December 5, 2019

**Subject: Addendum #1, RFP-1720-P
IP Intercom Systems**

Please note the following responses to questions received regarding the above Request for Proposal. These are questions that came from both the mandatory pre-proposal conference and questions that have been received since the meeting.

Elephant's Fork Elementary School 2316 William Reid Drive

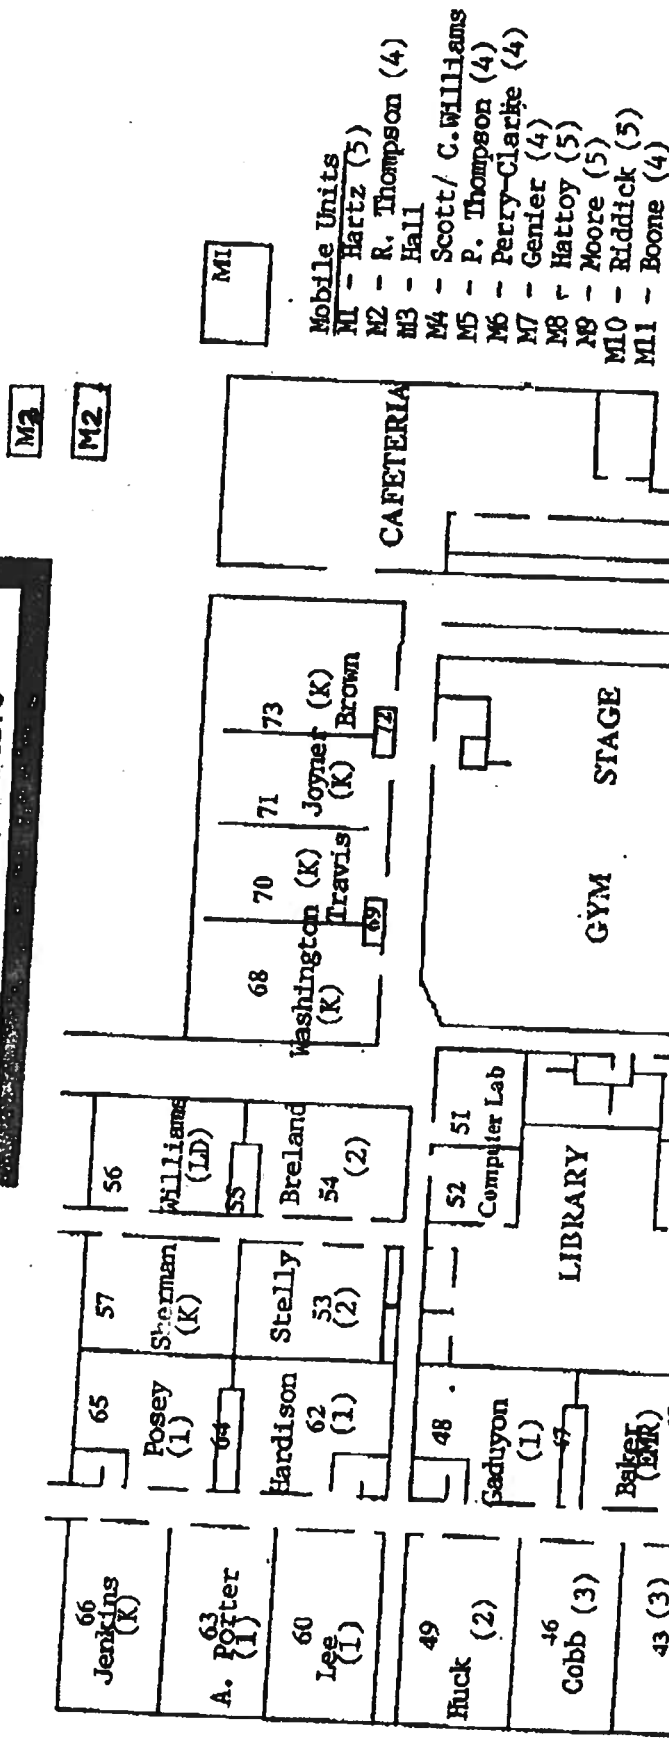
There are 13 physical mobiles at EFES. Mobiles 3 & 4 are divided. So, 15 total speakers
